# PRODUCT UPDATE

No. 260  
Date: 27.06.2013

## Key ordering Card – update for Interactive + G code

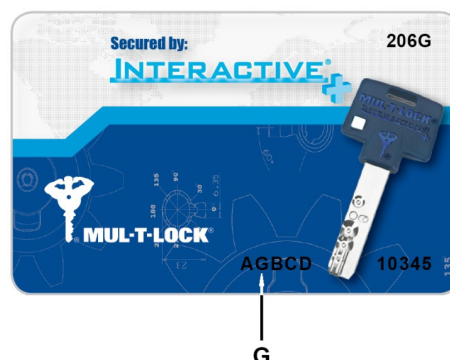
This plug pin must be assembled in the interactive chamber of all interactive+ G type only. To further upgrade the key ordering card of the Interactive+ (encoded magnetic strip), the printed combination on the card from now on will show "G" instead of A, to ensure assembling of the correct pin.

When the code is manually typed on the keypad or through the KC5 software, you should keep type in "A0" instead of "G0".
